RE: US Eagle Credit Union - Menaul 7201 Menaul NE Grading and Drainage Plan

Engineer's Stamp Date: 11/24/20 Hydrology File: H19D090

Based upon the information provided in your submittal received 10/14/2020, the Grading and Drainage Plan is approved for Building Permit and SO-19.

Issue Date: 11/24/2020 Architect: B. Bily Drawn By: PS Checked By: MS Project Number: 29643-0000 Title: DRAINAGE MANAGEMENT PLAN

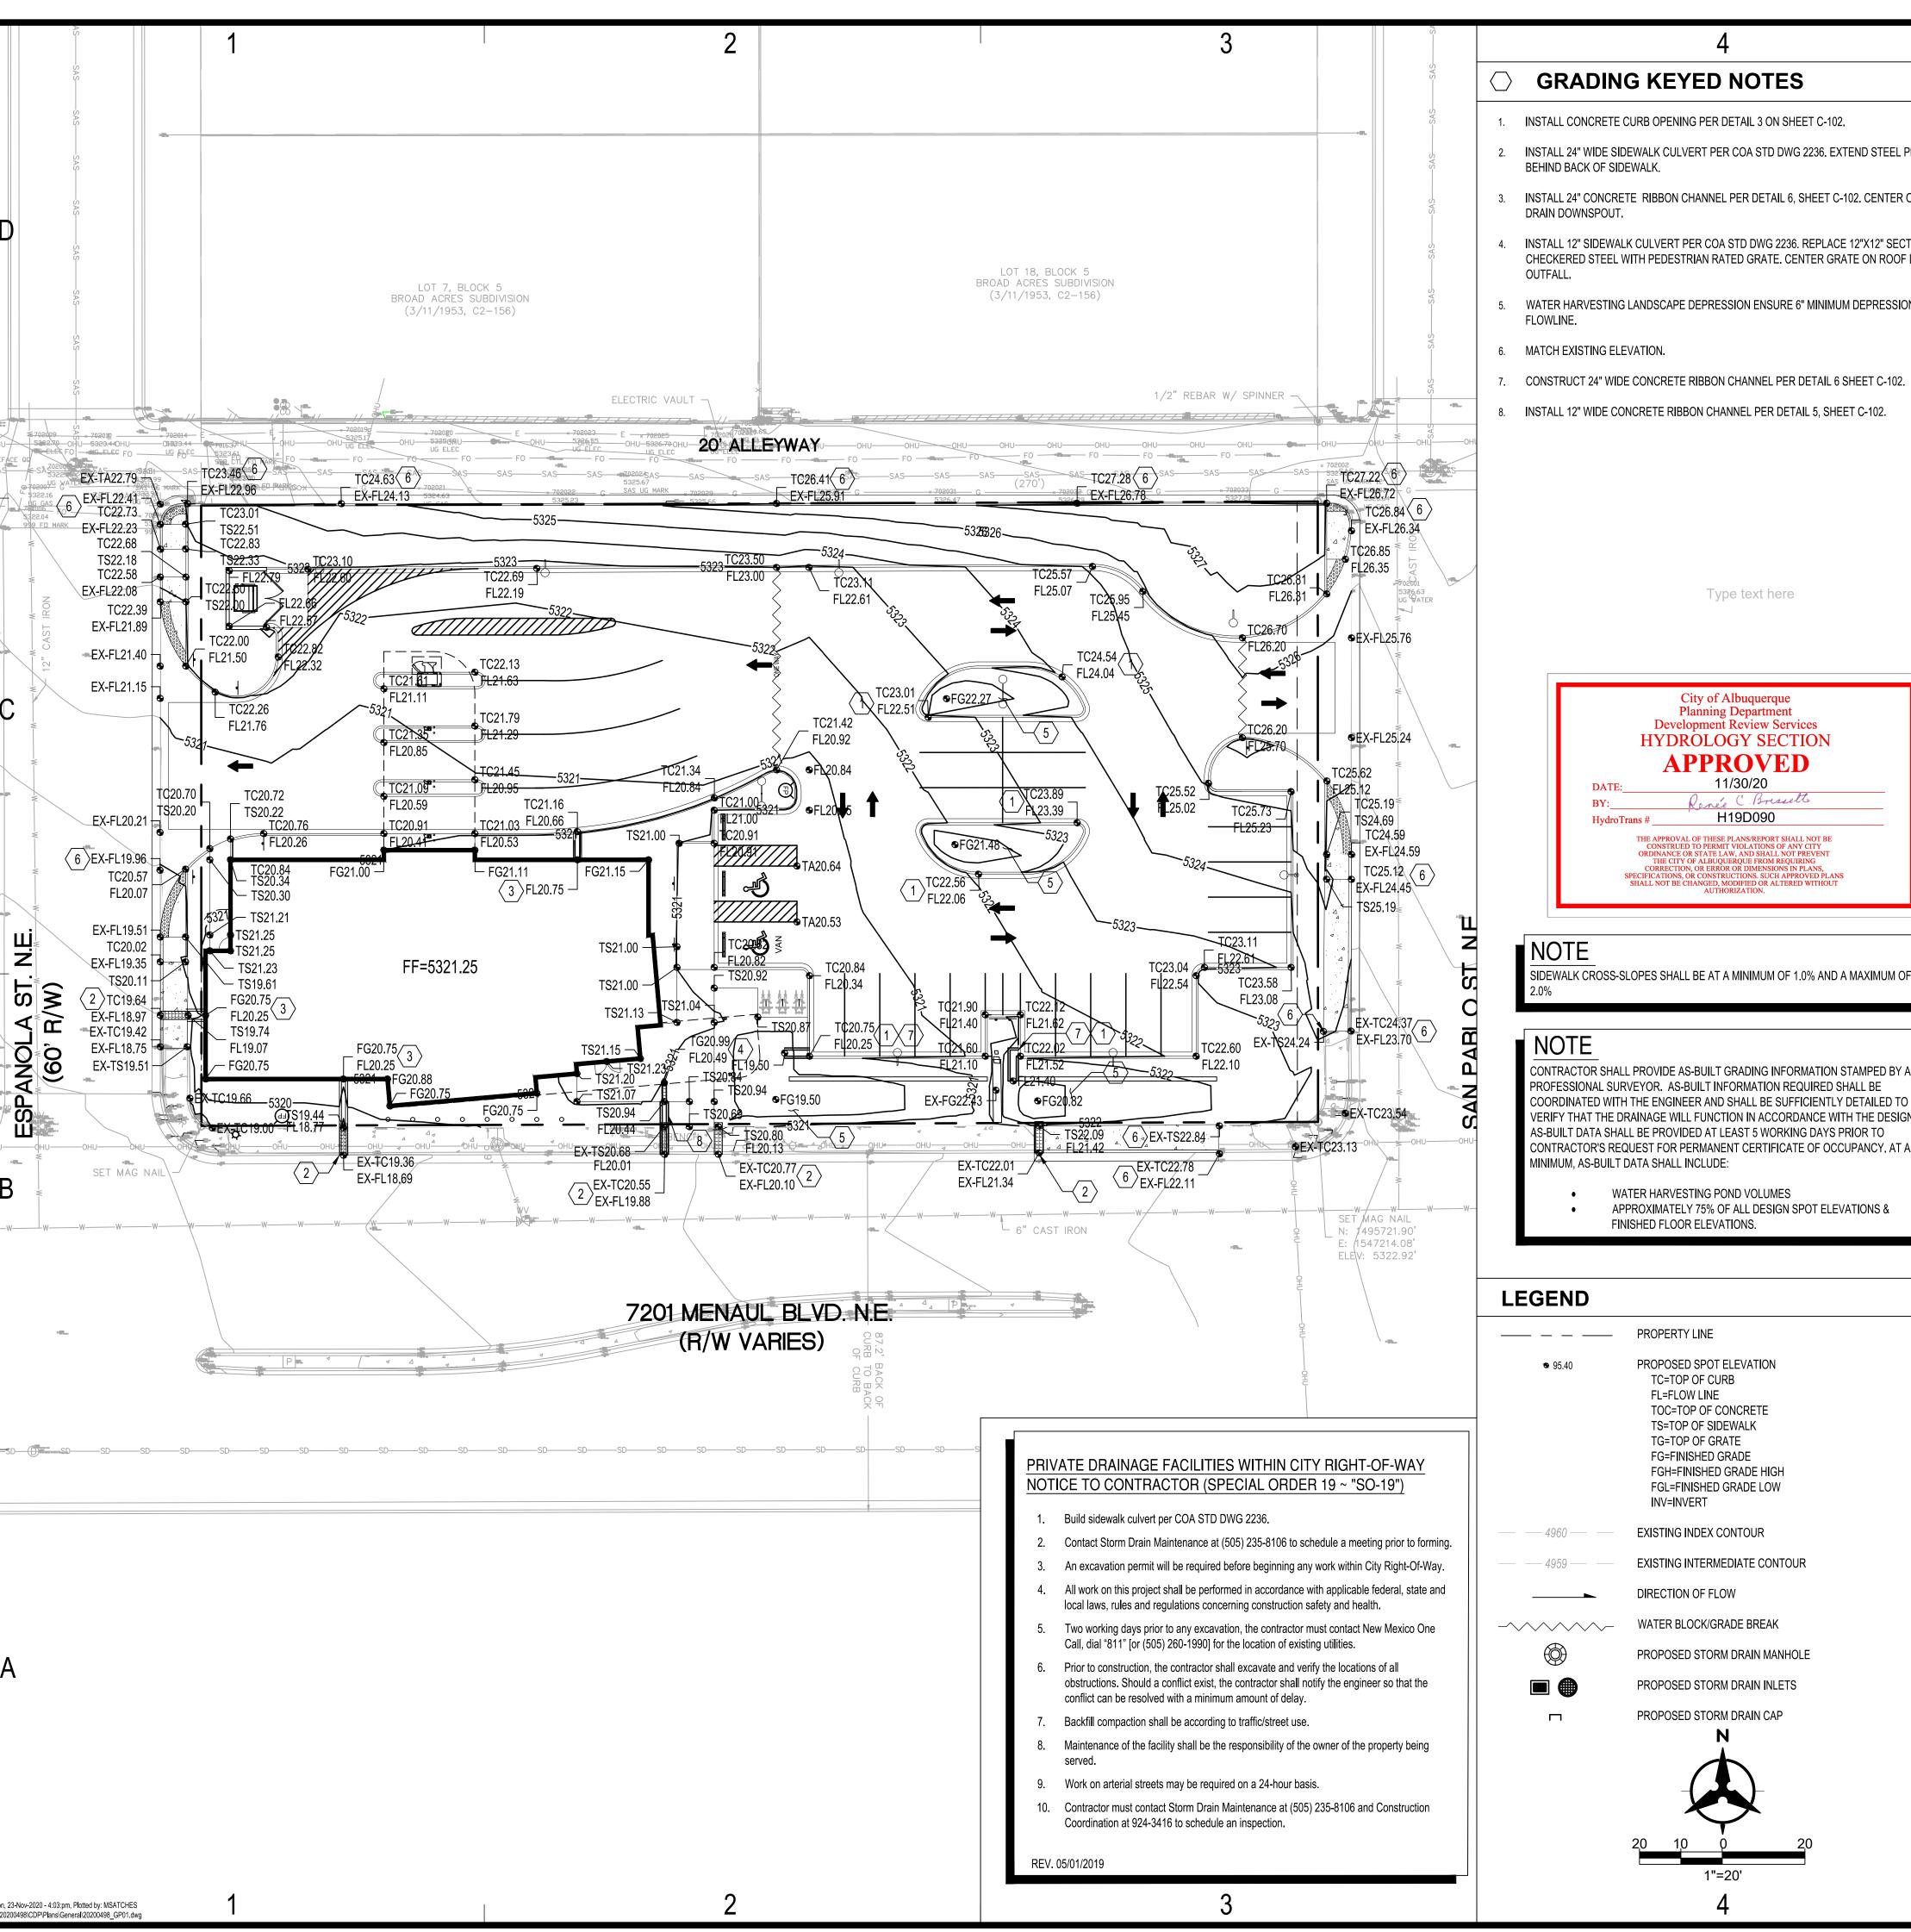
The Payment in Lieu payment of \$1,304.00 must be paid prior to Permanent Release of Occupancy approval. Please use the attached City of Albuquerque Treasury Deposit form. Once the Owner paid the fee, please provide Hydrology with a copy of the receipt.

Also, please provide the Drainage Covenant for the proposed stormwater quality ponds per Article 6-15(C) of the DPM prior to Permanent Release of Occupancy. There is a recording fee (\$25, payable to Bernalillo County). Please contact Charlotte LaBadie (clabadie@cabq.gov, 924-3996). Due to COVID-19, please follow the instructions:
